Access Compliance Report Public Rights-of-Way (Curb Ramps)

Main Street: ETON_PL Cross Street: O_NEILL_DR Location: N

ADA ID: RPRK211027120930 Ramp Type: Type 6 - Directional 1 Initial Pass/Fail: Pass Overall Compliance: No Severity Score: 16

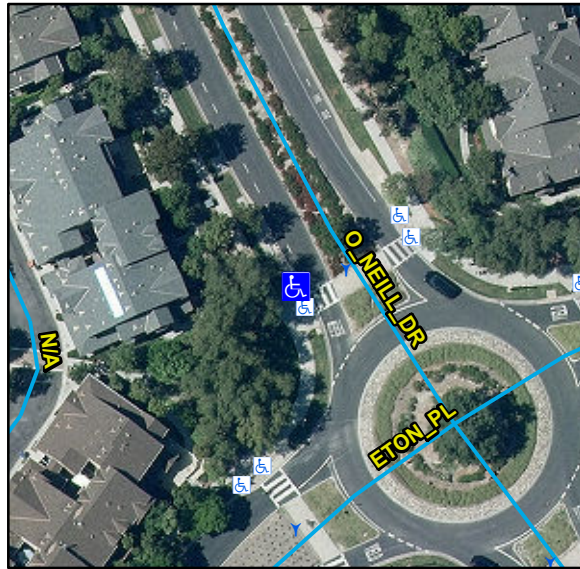
Compliance	Description	Data	Compliance	Description	Data
N/A	Ramp Length (in)	114	No	Flare Type LT	
Yes	Ramp Width (in)	48			Curbed1
Yes	Ramp Run Slope (%)	6	N/A	Flare Slope LT (%)	N/A
Yes	Ramp Cross Slope (%)	1	N/A	Flare Traversable LT	N/A
No	Grade Break	No	Yes	Flare Type RT	
N/A	Grade Break Slope (%)	N/A			Curbed2
N/A	Grade Break Cross Slope (%)	N/A	N/A	Flare Slope RT (%)	N/A
	Addl Para Ramp Left?	No	N/A	Flare Traversable RT	N/A
	Addl Para Ramp Right?	No	No	DWS Provided	No
N/A	Landing Present	Yes	N/A	DWS Contrast	N/A
Yes	Landing Length (in)	48	N/A	DWS Length (in)	N/A
Yes	Landing Width (in)	48	N/A	DWS Full Width	N/A
Yes	Landing Run Slope (%)	0.7		DWS Offset Type	N/A
No	Landing Cross Slope (%)	3	N/A	DWS Left Offset (in)	N/A
N/A	Landing Movement Obstructed?	No	N/A	DWS Right Offset (in)	N/A
	Landing Movement Type	N/A			
N/A	Landing Shared	No			
N/A	Marked Crosswalk 1	No	N/A	Clear Space	N/A
	Crossing 1 Direction	NE	N/A	Clear Space To Crosswalk (in)	N/A

Marked Crosswalk 1 Width (in)	N/A			
N/A	Ramp Inside Crosswalk 1	N/A			
	Crossing 1 Slope (%)	2.6			
	Crossing 1 Cross Slope (%)	0.6			
Yes	Gutter Ponding	No	Yes	Curb Slope	2.8
Yes	Gutter Lip Height (in)	0		Road Run Slope (%)	N/A
No	Gutter Run Slope (%)	5.2		Road Cross Slope (%)	N/A
Yes	Gutter Cross Slope (%)	0.8		Parallel Ramp Side	N/A
Yes	Overall Surface Condition	Acceptable	No	Perp Joint Present	No
	Cross Gutter Present?	No		Spandrel Present?	No
	Replace Cross Gutter?	N/A		Replace Spandrel?	N/A

Remove & Replace Entire Ramp. Remove & Replace Gutter.
